Panel Report

Yarra Planning Scheme Amendment C231

Queens Parade Built Form Review

31 October 2019

Figure 2: Plan of area to be rezoned and application of EAO in Precinct 3

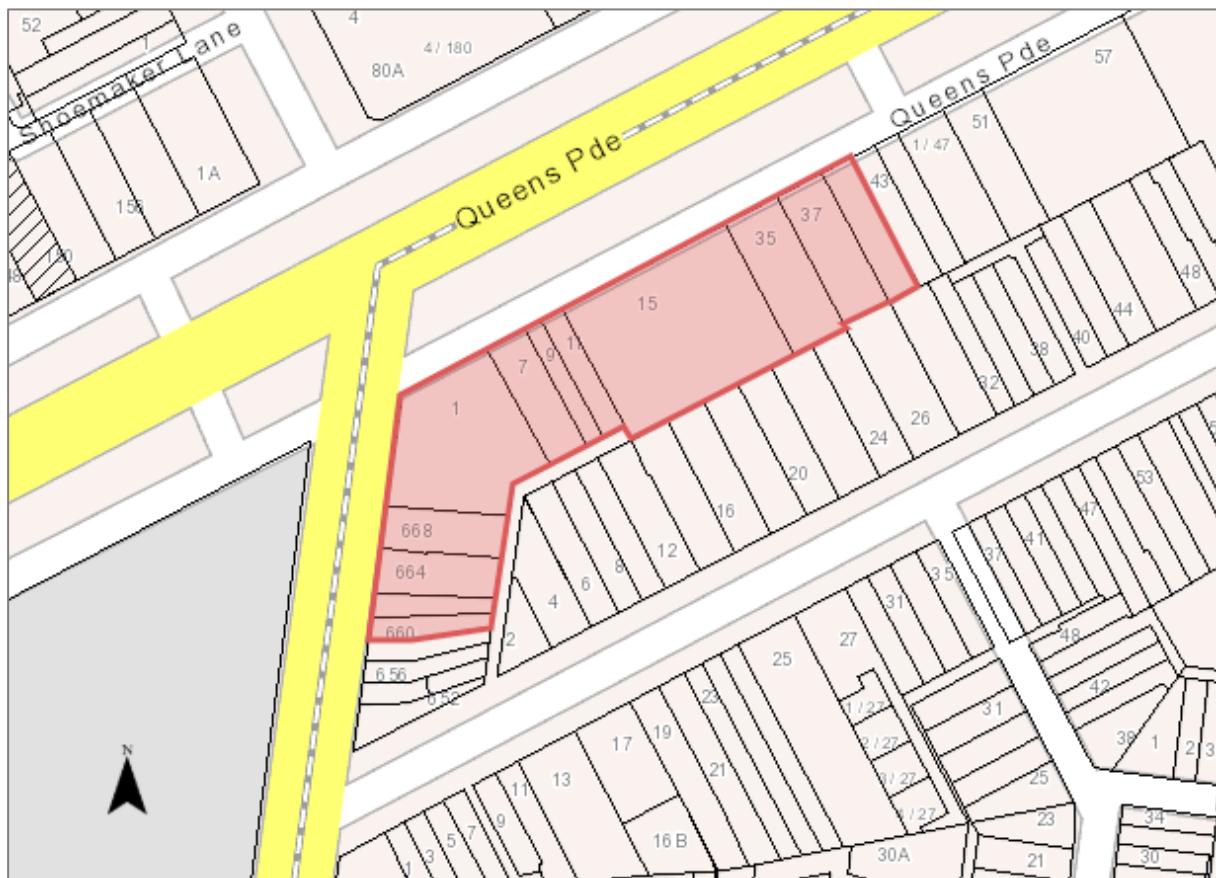
The Amendment proposes to rezone an area of land located in Precinct 3 at 660 – 668 Smith Street and 1 – 41 Queens Parade from the C2Z to the C1Z and apply the EAO over that parcel of land (Figure 2).

Figure 5: Map of Precinct 3

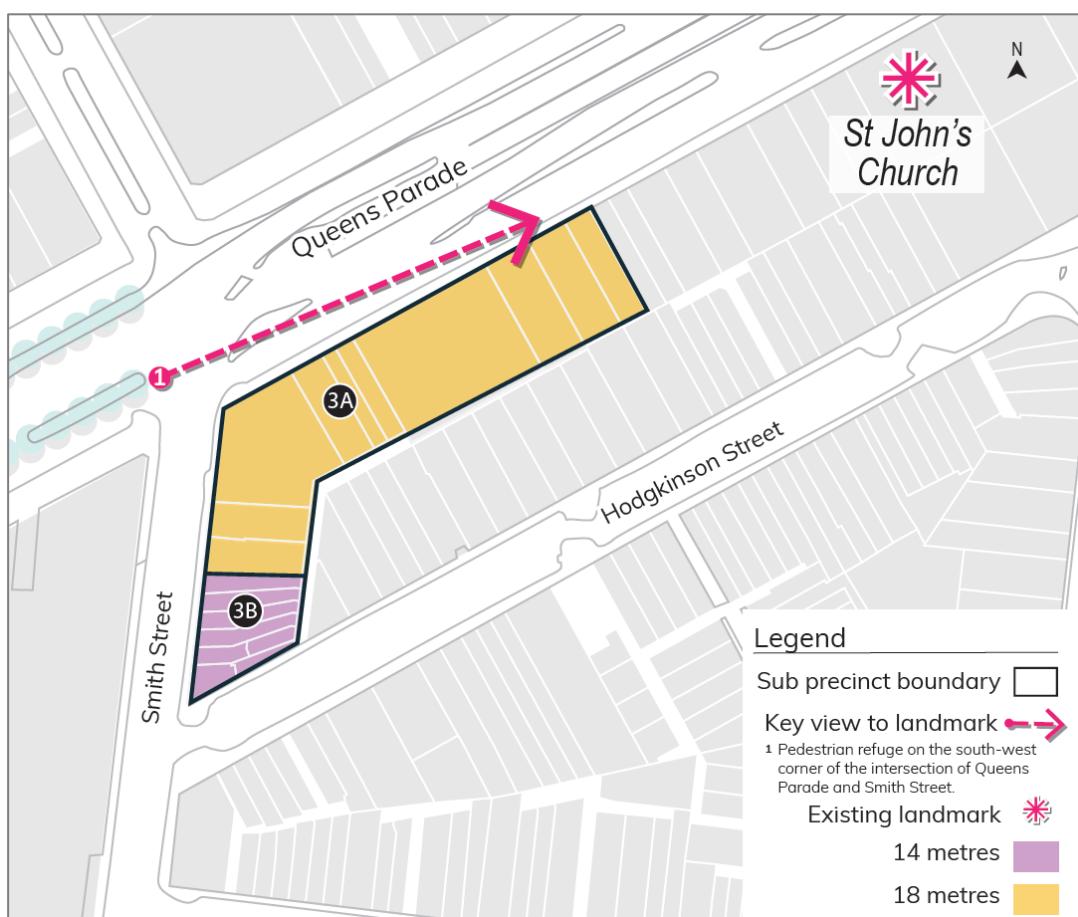
Mr Parsons questioned the value of the mandatory requirement to require clear sky to be retained around the spire and belfry of St Johns Church when viewed from the key viewpoint identified in Figure 5. He opined that while the viewpoint in the preferred DDO16 allowed a view of the spire, it was not helpful in assessing the impact of different heights. He observed this view was not noticeably impacted by development at heights greater than the proposed mandatory maximum height of 18 metres.

The Panel considers this confusion was partly due to modelling of the view that did not accurately reflect the conditions (e.g. Figure 7.9 in Mr Parsons evidence statement). The modelling did not include any trees, street infrastructure or street furniture that in the actual view, impact or partly obscure the view. To appreciate all components of that view, a viewer standing in the nominated location would have to make several observations from several slightly different locations.

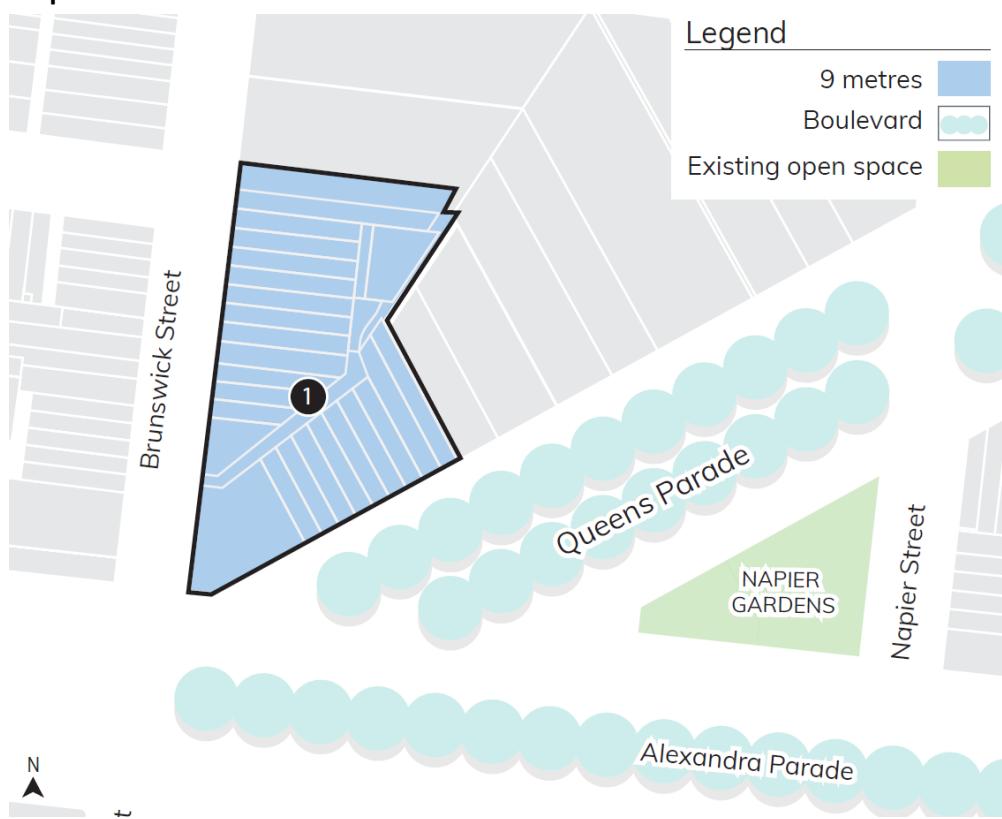
Buildings and works should deliver ~~the following preferred precinct character~~:

- Properties fronting Brunswick Street and turning the corner to Queens Parade defined by fine grained low scaled heritage buildings, with-

~~Moderate-moderate~~ low rise future infill behind the main heritage frontage, ~~supported accessed~~ by rear laneways ~~access~~.

- Visual prominence of the individually significant heritage building on the corner of Brunswick Street and Queens Parade retained.

Map 5 - Precinct 5

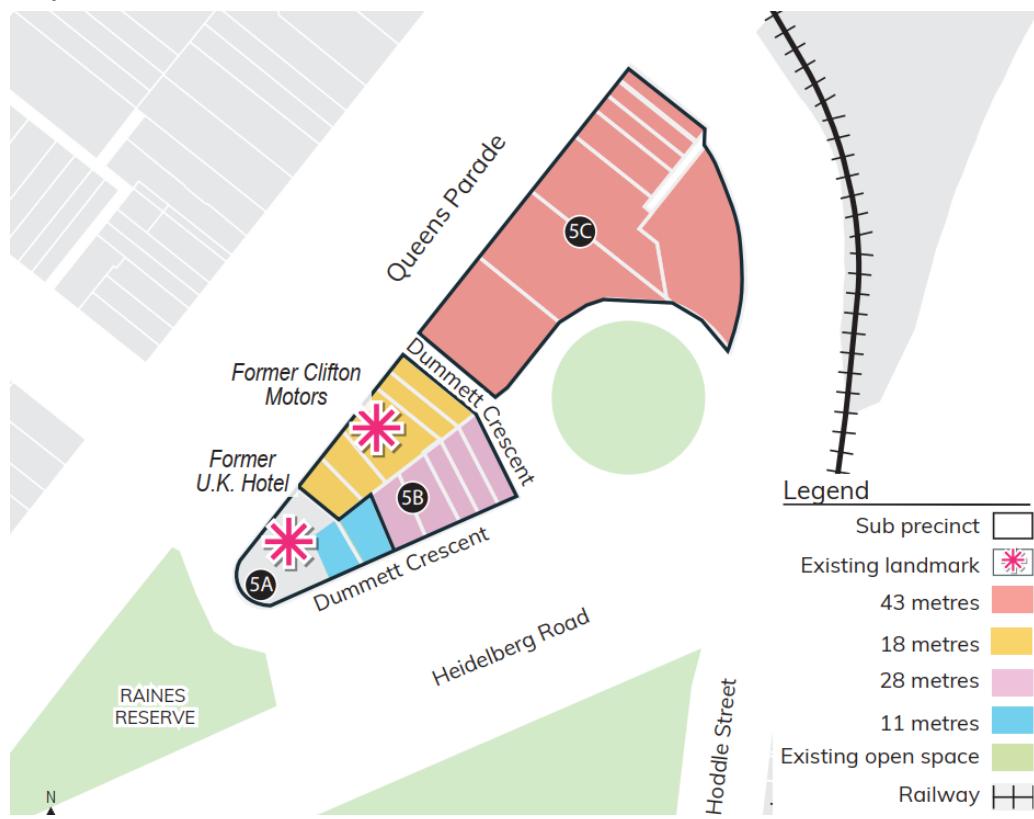
[Include the viewpoints](#)
